BELL SYSTEM PRACTICES  
Teletypewriter and Manual  
Telegraph Station and PEX  
Installation and Maintenance

ADDENDUM P30.502  
Issue B, 9-1-39  
Long Lines Department

L9.05 19 TTY SET - 19 - A TABLE - DUPLEX OPERATION (See PMS.13 - 9.18)

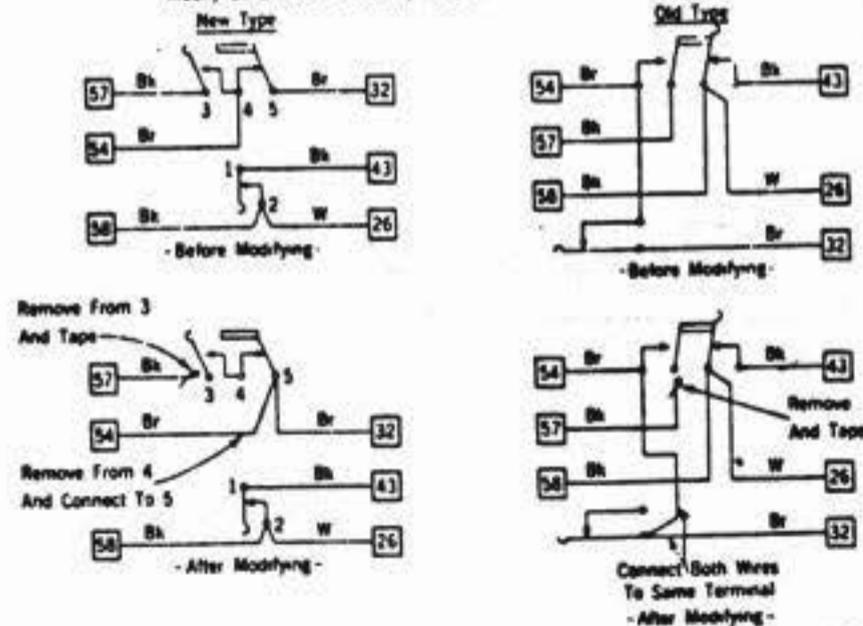
NOTES: Remove Strap Between TTY Terms 32 And 42  
Transfer Red Wire On Table Term. 6 To Table Term. 7  
Add Wire Between Table Term 6 And Table Term. 7  
Disable Line Test Key In Accordance With Plan M210  
Modify Send Rec Break Key As Shown Below

L 9.08

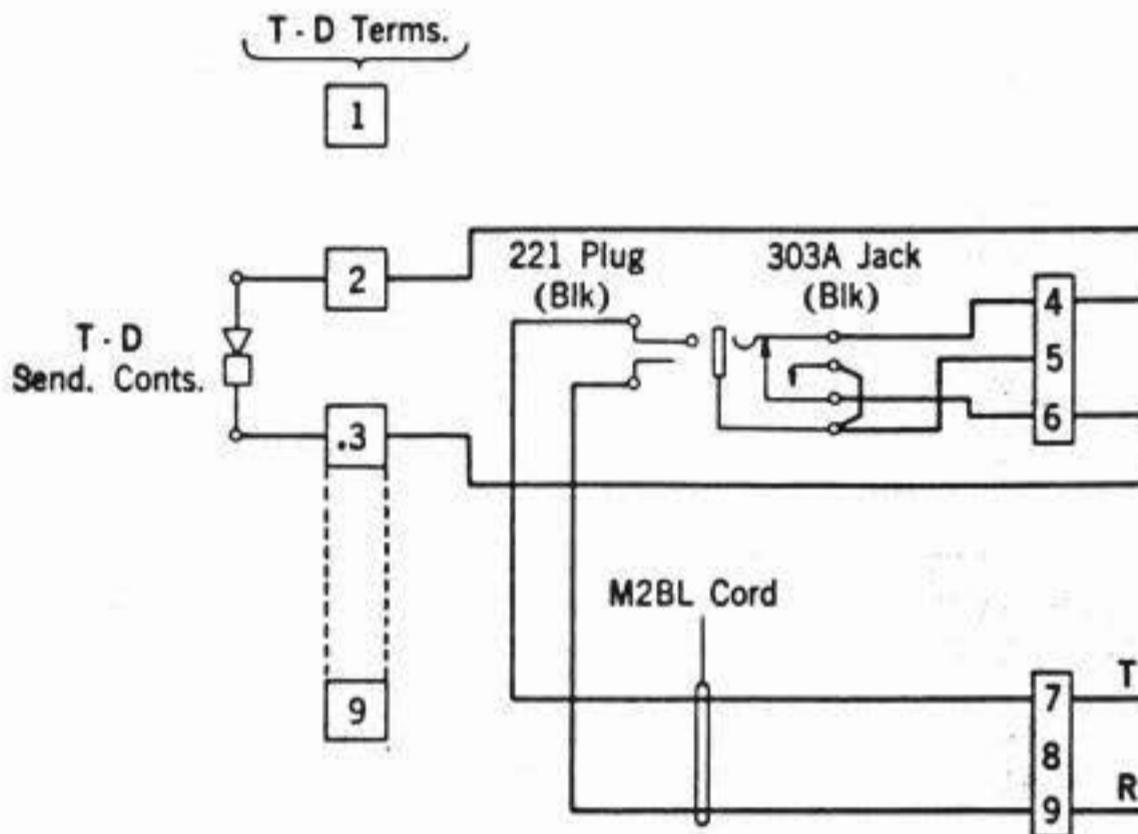
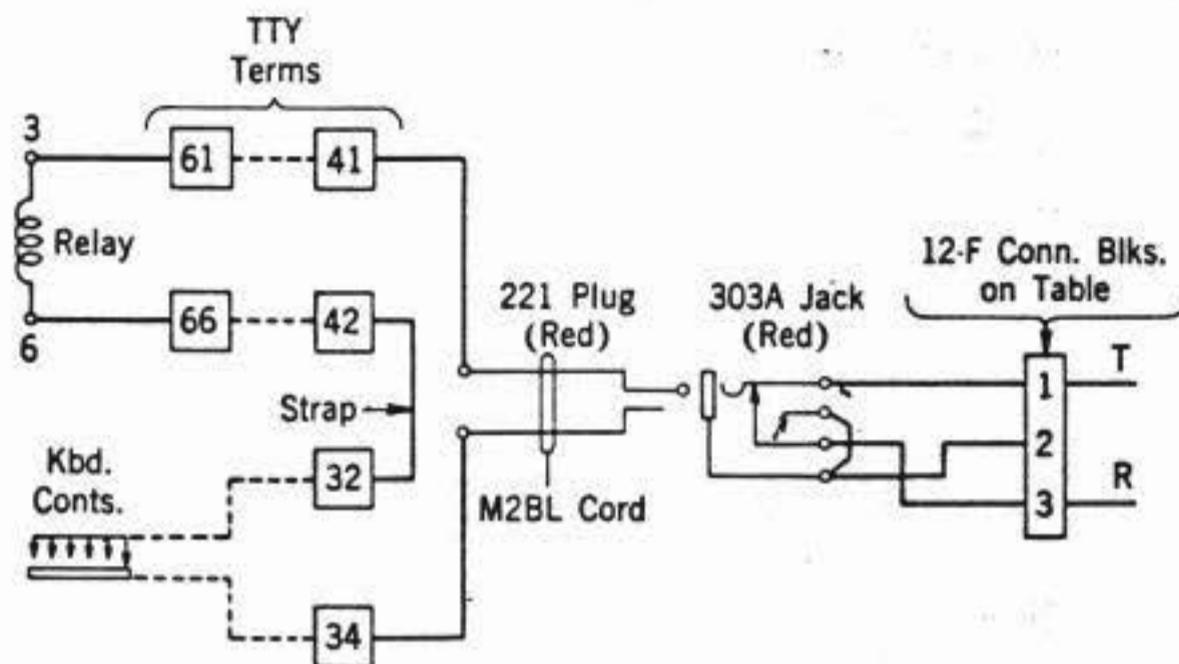
1.02 Connection Plan L9.08 provides information to permit the rearrangement of a No. 19 teletypewriter set equipped with the remote motor control arrangement, so that its transmitter-distributor can be used as an independent unit and the remainder of the set as another unit.

19 TTY SET 19-A TABLE.  
MODIFICATION TO PERMIT TRANS. DIST. TO BE  
USED AS AN INDEPENDENT UNIT AND  
REMAINDER OF SET AS ANOTHER UNIT.  
REMOTE CONTROL OF TTY MOTOR PER BSP P30.752
